ITCAC (Integrated Transportation Community Advisory Committee)

Item 3.2: Notice of Planning Application - Official Plan and Zoning By-law

Amendments - 610-620 Beaverbrook Avenue

Prepared by: John Vareka (ITCAC committee member)

Fig 1: Google map route from Budweiser gardens to 610-620 beaverbrook ave. (2.6km distance)

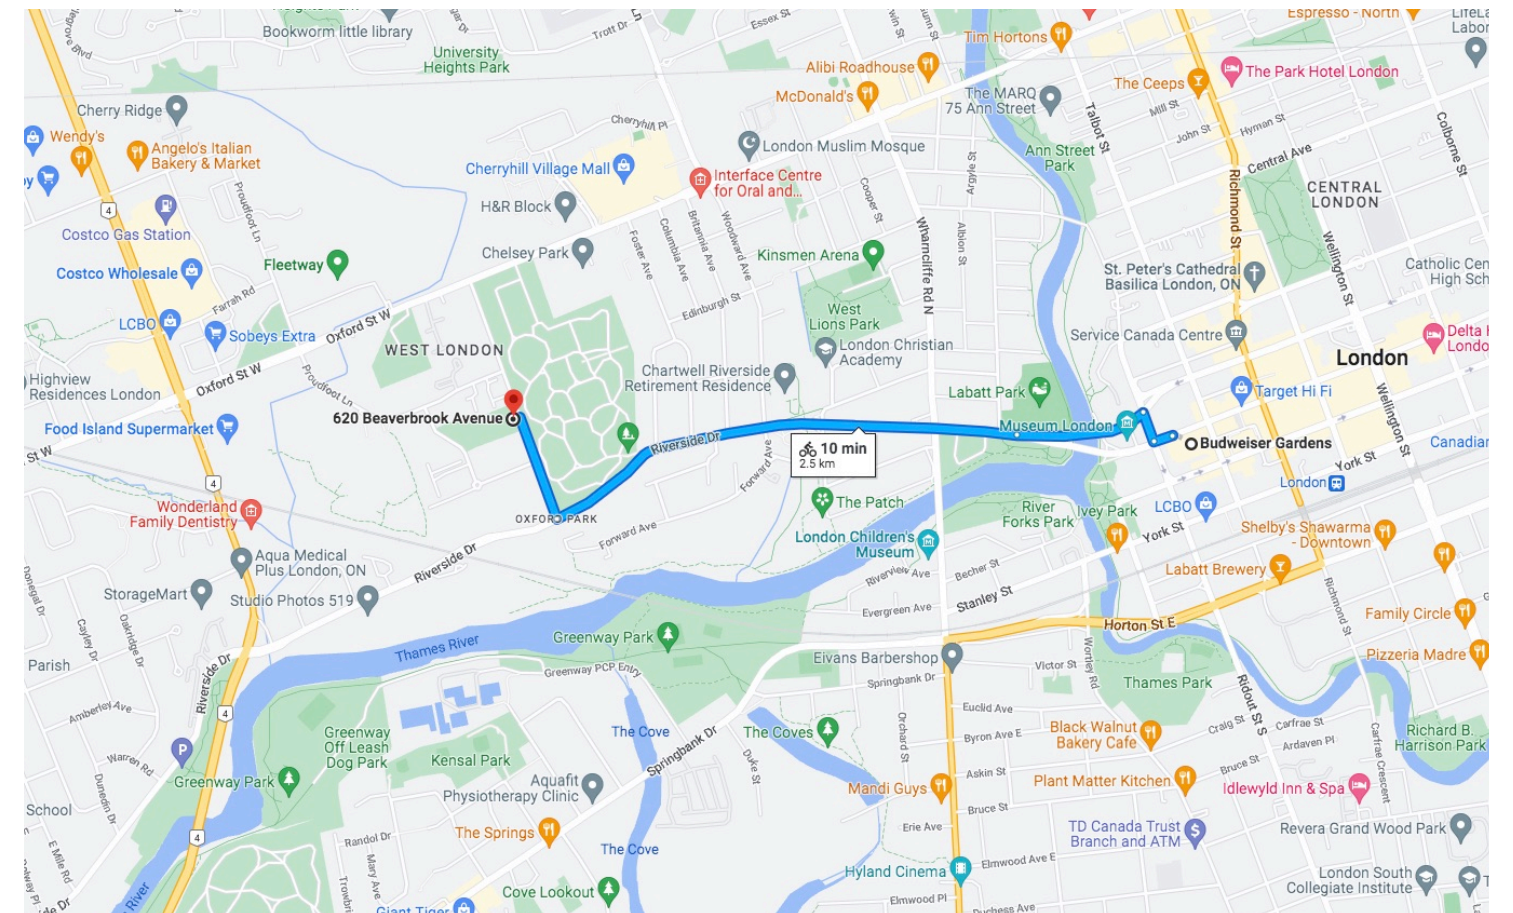
I biked from downtown (Budweiser Gardens) to the development site at 610-620 Beaverbrook Ave, to look at the building site and to get a feel for how one could walk or cycle to this development in the Proudfoot neighbourhood from downtown. The distance travelled was 2.6km which I would consider a good distance for cycling trips. Dedicated lanes from downtown to Wharncliffe were comfortable to ride on and appreciated.

Fig 3: Beaverbrook Ave. showing 2 separate sections (in red) with the same name.

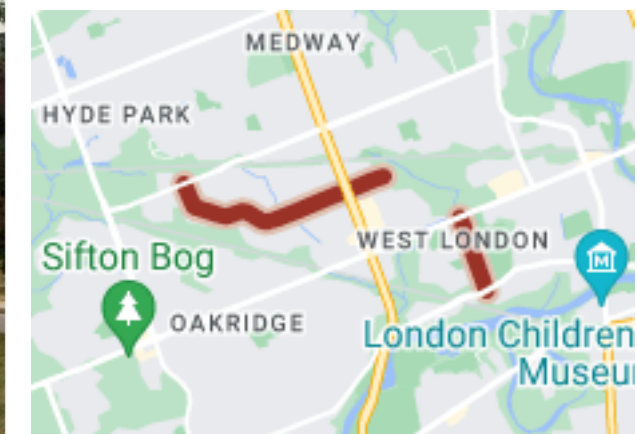
3-4) when I originally googled 'Beaverbrook Ave.' a different part of the road further north-west appears. (see Fig. 3). I don't consider this high priority but perhaps discussion could be had on whether it makes sense to rename 'Beaverbrook Ave.' between Riverside and Oxford street to reduce confusion (since fewer addresses would likely be impacted). Public outreach may be needed to see if it's actually an issue or just an annoyance...even a minor change to 'Beaverbrook Drive' or something similar would help differentiate it enough.
